SUBJECT: Initial Draft of MIL-PRF-26542/2E (1): "MICROPHONE AND MICROPHONE ASSEMBLY, M87/AIC, M26542/2-01, M26542/2-02, M26542/2-03, M26542/2-04".  
Project number 5965-0422-000

MIL-PRF-26542/2E  
 w/AMENDMENT 1  
 DRAFT  
 SUPERSEDING  
 MIL-PRF-26542/2E  
 16 July 2002

MICROPHONE AND MICROPHONE ASSEMBLIES,  
 M87/AIC, M26542/2-01, M26542/2-02, M26542/2-03, AND M26542/2-04

FIGURE 1. Microphone assembly.

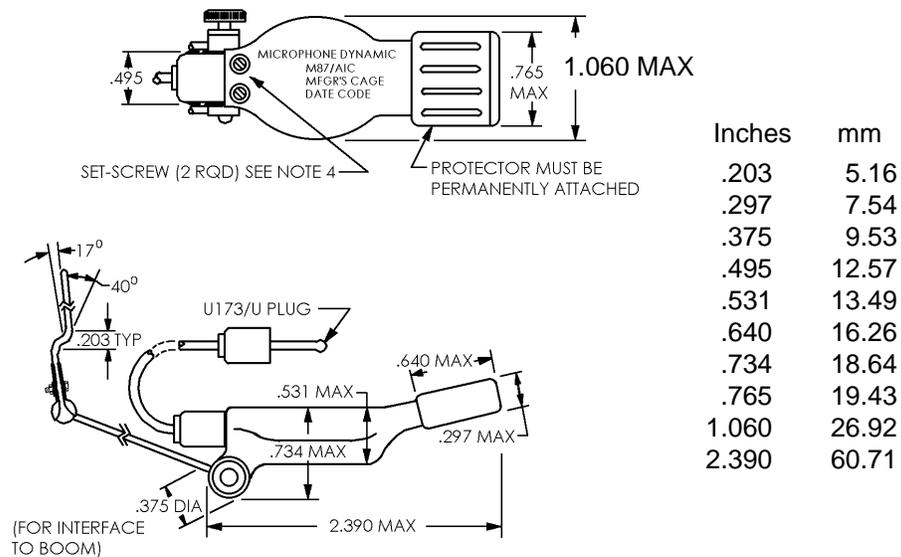
The changes include correction of the outer case dimension (1.060 MAX), replacement of the related entry to the metric conversion table on figure 1, inclusion of interchangeability inspection, and minor editorial updates.
